# Access Compliance Report

## Public Rights-of-Way (Curb Ramps)

Intersection ID: 47754	Main Street: REBECCA_RUN_DR	Cross Street: BROCK_RN	Location: S
ADA ID: 2084633CA670	Ramp Type: Perp	Initial Pass/Fail: Pass	Overall Compliance: No
Codes/Mitigation Info/Possible Solution		Field Measurements/Component Compliance	
Severity Score: 5

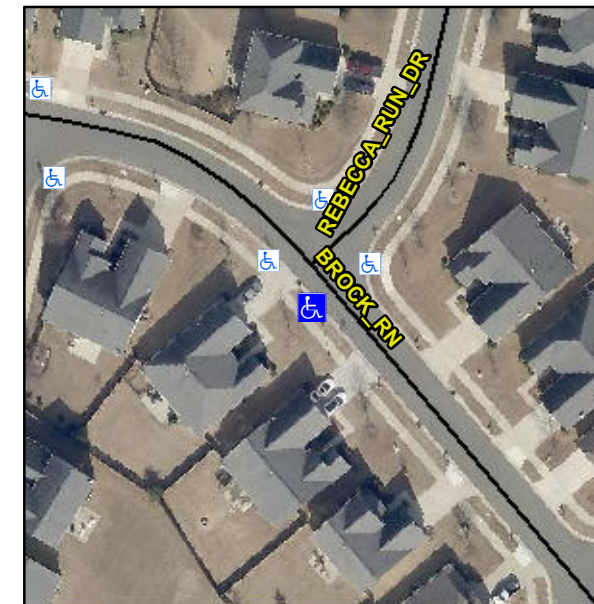
**Not Found, R304.5.4**

**Remove & Replace Entire Ramp.  
Remove & Replace Gutter.**
